# **DEVELOPMENT CONTROL COMMITTEE**

**2. Item 6 - 20/02802/FULMMA - Sites A and B, Lizard Drive, Snelshall East, Milton Keynes**

**Application Number:** 20/02802/FULMMA

## **UPDATE PAPER**

Figure 1: measurements taken from GIS software

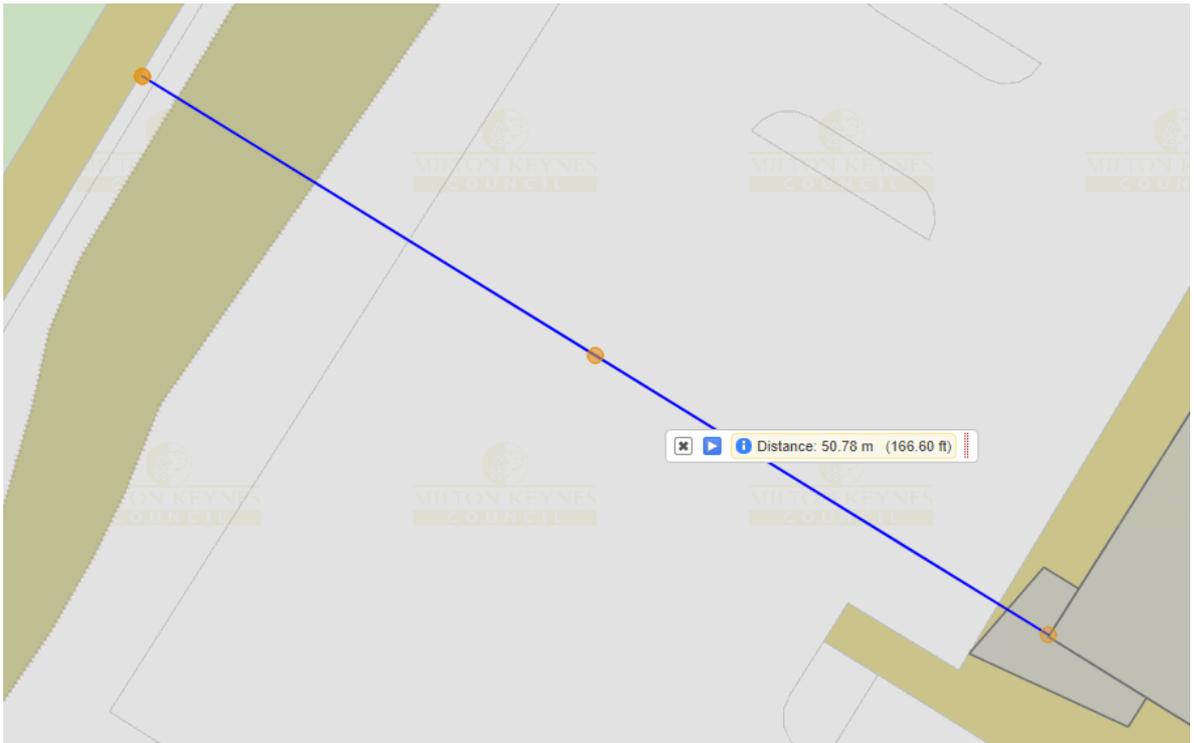
Comment that it may be that the landscaping problem has arisen because the warehouse has not been built in the approved location, now being too close to the park edge, as a result of which the agreed landscape scheme cannot be implemented. They ask for confirmation that the setting out has been verified by checking the approved plans against what has been built on the ground.

- 3.1 As set out in the main committee report, the position of the building is not being amended as part of the proposal, with it in exactly the same place as in the approved application when comparing the drawings submitted under both applications. The building is already constructed and it has been confirmed through comparison of Ordnance Survey (OS) base mapping, aerial photography and the proposed site layout that the building is in the correct place. It is also clear from site visits that the car park has been laid out in accordance with the now proposed plan leaving the correct width for the landscaped embankment.

- 3.2 For clarity, the northern corner of the building is shown as 36.5 metres from the redway on the site layout. At the western corner, there is 50.9 metres from the building to the redway. These distances have been checked against recent OS mapping on GIS software, where distances of 36.7 metres and 50.8 metres are obtained respectively. When accounting for marginal scaling/manual measuring errors, the apparent 10-20cm +/- deviance is considered to confirm the correct setting out of the building. These comparisons are shown in Figures 1 and 2 below.
